OneX Towers

DRB

MARCH 13, 2023

#3036780-LU

2. MASSING AND DESIGN CONCEPT

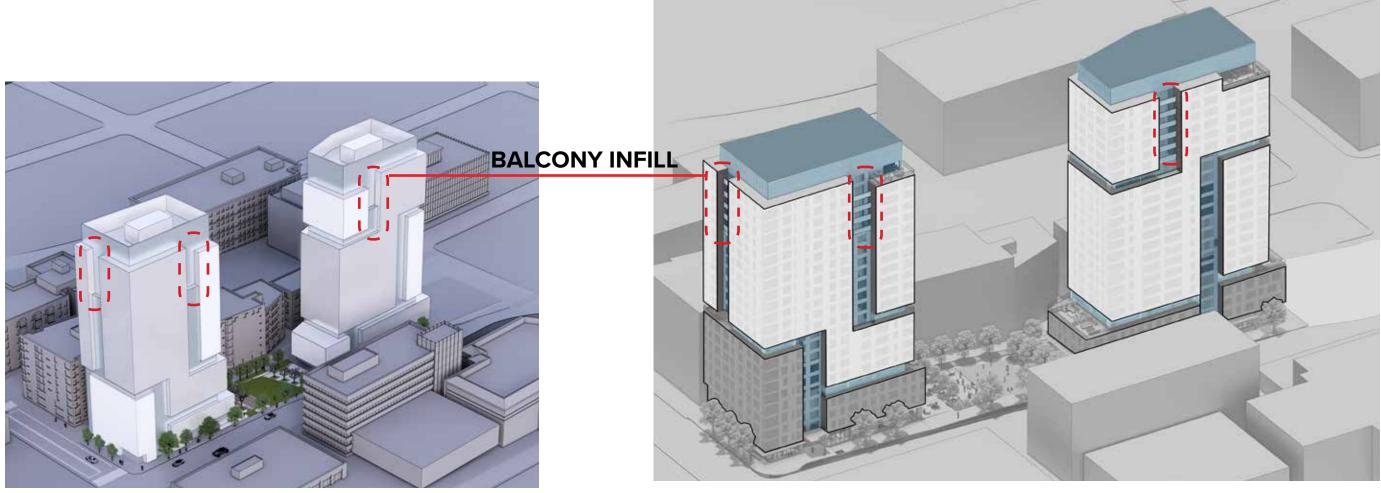
COMMENTS	RESPONSE	DESIGN GUIDEL
b. The Board was concerned that the secondary modulation that occurs in the areas between the larger modulations(shown in grey on page 110 of the Second EDG packet and elsewhere) could weaken the design concept and that some simplification of the number and articulation of moves could be successful in strengthening the overall design concept and achieving an overarching compositional order. (CS3-1, DC2)	The EDG 2 vertical modulation reads as though its stops before the roof terminus. We agree with the boards comments and we have refined the design so the vertical modulation is continuous to the roof. The inset windows of the modulation erode to balconies at the top of the massing but it reads as one articulation. The glass railings of the balcony infill are aligned with the façade below, creating the impression of a single plane within the recess. This helps to integrate the balconies seamlessly into the overall design of the building. These balconies encourage outdoor activition for residents while also providing stunning views.	DC2-C-1. Visual where appropri awnings, decks, design. Add de interest for the p window shoppir

3. DESIGN CONCEPT (continue from previous page)

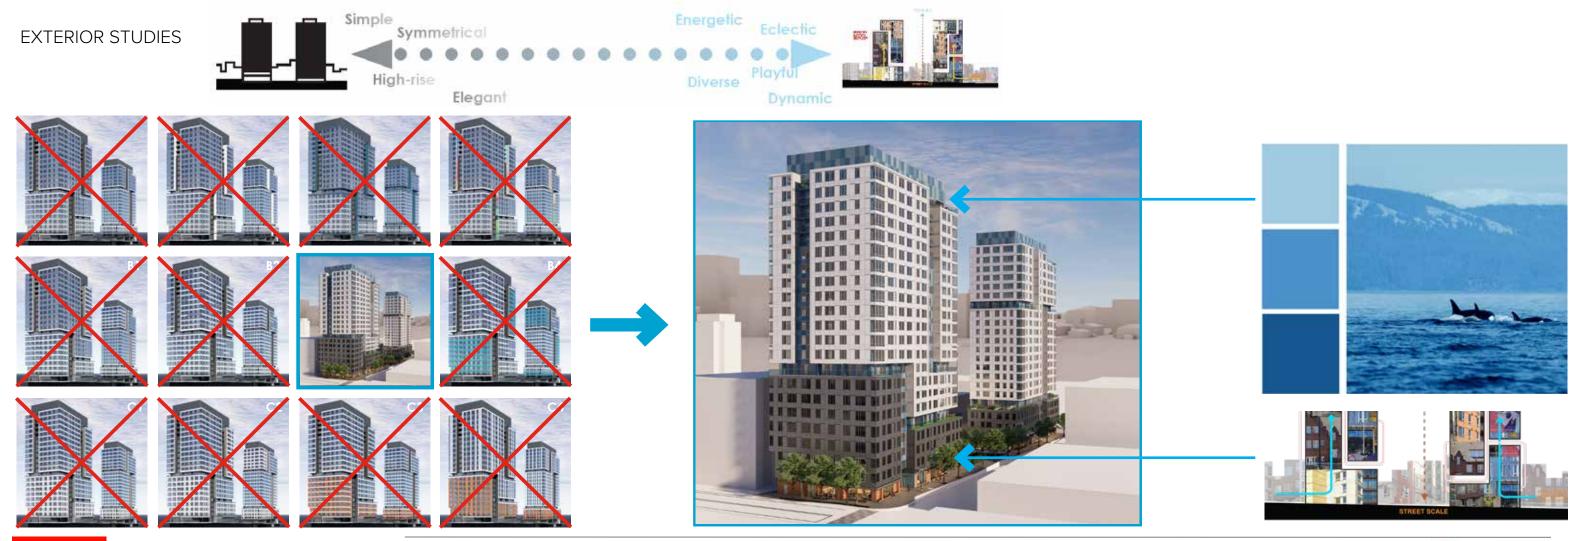
b. The Board supported the design concept demonstrated by diagram #5 on page 56 of the Second EDG packet but was concerned that the precedent images provided in support were all smaller projects. The Board stated that scaling-up this design concept for a much larger project and reconciling the collage-like elements presented an interesting challenge, one that would require a strong solution to be presented at the Recommendation phase. (DC2, CS3-1)

In listening to the board's comments and concerns around the scalability of the precedent imagery, we have let the big articulation moves of the massing take lead, while the facade treatment is simplified and balanced. The warm bronzy-colored masses serve as an anchoring base that relates to the scale and materiality of the surrounding context, while the tower's lightcolored facade treatment helps to lighten its visual weight. To create a playful treatment and blend the tower into the sky, we have incorporated rich multi-colored blue panels between the primary massing and on the mechanical screen at the top. The tower's grid and windows have compositional movement, as we have optimized the amounts of vision glass with the internal program, resulting in smaller windows for bedrooms and larger windows for living rooms and common spaces.

3. DESIGN CONCEPT

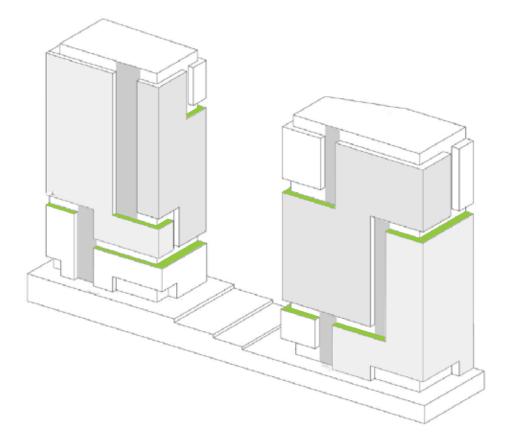
c. The Board supported the creation of occupiable exterior space in the towers (as identified by the green-shaded areas on page 119 of the Second EDG packet) and stated that the active use and compositional strength of these elements should be preserved and strengthened as the design is developed and those areas programmed. (DC2, CS3-1, DC3, DC3-2

The occupiable exterior spaces have not changed since EDG2. They have been strengthened by the overall concept and design which is the strong horizontal modulation and vertical articulation of the towers, which is influenced by the interior programming. The podium roofs and level 5 horizontal recesses have been designed as large outdoor amenity terraces, which are accessible from the interior amenity space via a porous and transparent exterior façade. These terraces provide a visual connection to the central green space and create a sense of community within the development.

In addition to the communal terraces, the upper-level horizontal modulation in the towers includes private outdoor terraces for the residential units. Balconies have also been incorporated at the top of the tower for units within the vertical modulation. This variety of outdoor spaces caters to the different needs and preferences of the residents.

4. PODIUM MASSING AND STREET EDGE

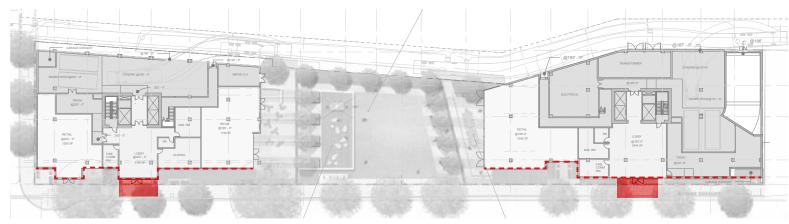
COMMENTS	RESPONSE	DESIGN GUIDELI
a. The Board stated that the connection between the lower-level massing moves and ground plane programming, most particularly the primary entries, was unclear and that clarifying and strengthening this relationship would be essential for the project's success. (PL3-A, DC2, DC2-6, PL3-1, PL3-3)	Based on the design review board's feedback, the ground-level programming and geometry have been revised to address their guidance. The main entries have been relocated to the vertical recesses along Roosevelt, creating a strong architectural identifier and providing a transition zone from the sidewalk to the interior of the building. This new alignment also enhances the sense of arrival and makes the building more welcoming to visitors. Along the north and south edges of the central plaza, the 2nd level massing overhangs the ground level to provide a covered transition zone between active interior and exterior spaces. The street-facing facades have been simplified to extend to the back of the sidewalks along Roosevelt and 47th Avenue, creating an urban edge and connecting the interior active uses to the streetscape through transparent facades. This design decision helps to create a sense of continuity along the street and reinforces the connection between the building and the surrounding community.	PL3-1-a. Prominent E vertical emphasis ar high-quality materia welcoming experier PL3-B-1. Security and buildings through the development and the PL3-B-4. Interaction: neighbors. PL3-1-b. Grade Septo building floor plates for commercial alon

Revised Site Plan

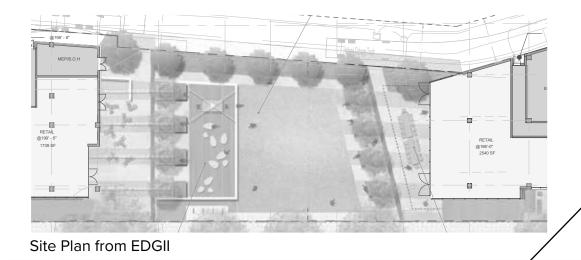
COMMENTS	RESPONSE	DESIGN GUIDEL
g. The Board supported the differentiated paving and color palette proposed for the alley as well as a midblock crossing at Roosevelt Way NE but recognized the Seattle Department of Transportation's purview over right-of-way improvements. (PL1-2, PL2-D, DC3)	Understanding the importance of preserving the east-west connection through the site, the revised landscaping plan achieves this goal while also adhering to SDOT's preference for maintaining the existing paving within the alley by creating open vistas that provide a visual connection into the community.	PL1-1-d. Treat all al windows, entries, c facades to activat PL1-2-b. East-west alley are strongly e Pedestrian Pathwc approximate midd for mid-block pede

Updated Central Plaza

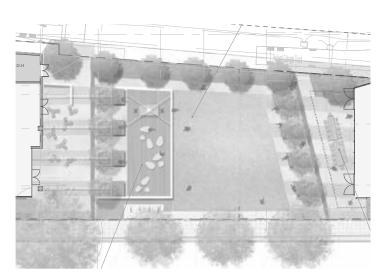
COMMENTS	RESPONSE	DESIGN GUIDEL
 a. The Board expressed strong support for the evolution of the central open space to be open to the sky rather than partially covered. b. The Board stated that a strong connection between the retail areas and the open space was critical to creating the dynamic and engaging qualities called for in the Guidelines. (PL3-3, DC3-1, PL3, DC3) 	The active outdoor spill-out space adjacent to the north tower can be accessed from multiple points, including the central plaza, the sidewalk, and via large overhead doors in the storefront. This design increases the usability and accessibility of the space and encourages its use by the surrounding community. In addition, the spill-out space can even be accessed from the neighboring greenspace across the alley to the east, further increasing its connectivity to the surrounding environment. The plaza area adjacent to the south tower has also been subtly recessed to align with the ground-level elevation of the retail within, creating a seamless indoor/outdoor transition. This design decision enhances the sense of continuity between the interior and exterior spaces and creates a more cohesive and welcoming environment.	PL3-C-2. Visibility and merchandi wall-sized doors increased heigh PL3-1-b. Grade entries: Step bui raised or below- sidewalk.

5. CENTRAL OPEN SPACE

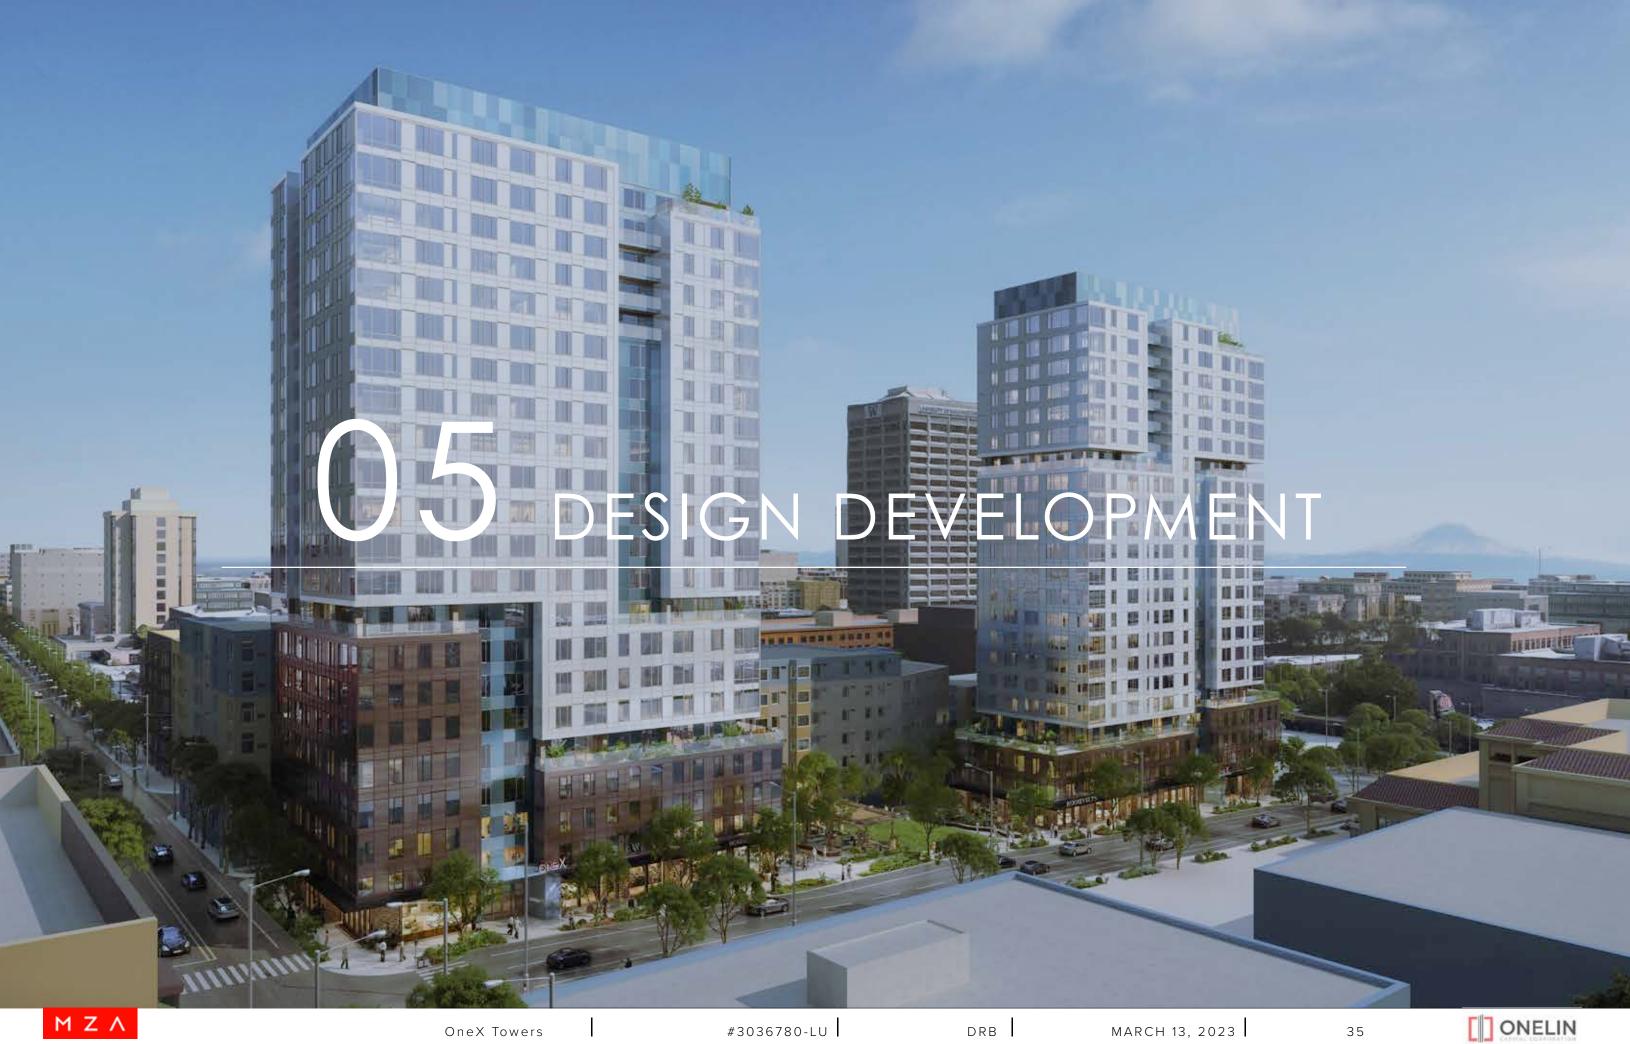
COMMENTS	RESPONSE	DESIGN GUIDELII
e. The Board noted that the retaining wall steps, as shown on page 112 of the Second EDG packet, could be less abrupt and better connected with site topography. The Board stated that permeability along the alley edge was an important element in activating the open space, but that it would not need to be continuous if the principal pathways through the site were clearly open and welcoming to pedestrians travellin through the alley. (PL1-1, PL1-2, DC3-1, DC3-2, DC3) f. The Board expressed strong support for the potential for dynamic connections between the occupiable exterior areas in the towers and the central open space. The Board provide guidance to refine and strengthen this relationship as the design develops. (DC1-1, DC3, DC3-2-a, DC1-1-c, DC1-3)	 topography. This creates a seamless visual connection between the alley and the central open space, promoting a cohesive and connected environment. We also understand the importance of encouraging East-west mid-block pedestrian connections. We have incorporated multiple access points from the street through the central open space to the alley. This will provide more opportunities 	PL1-2-a. Pedestri movement path pedestrian-prior mid-block pede PL1-2-b. Connec connections fro blocks within the Projects within the preferred locati
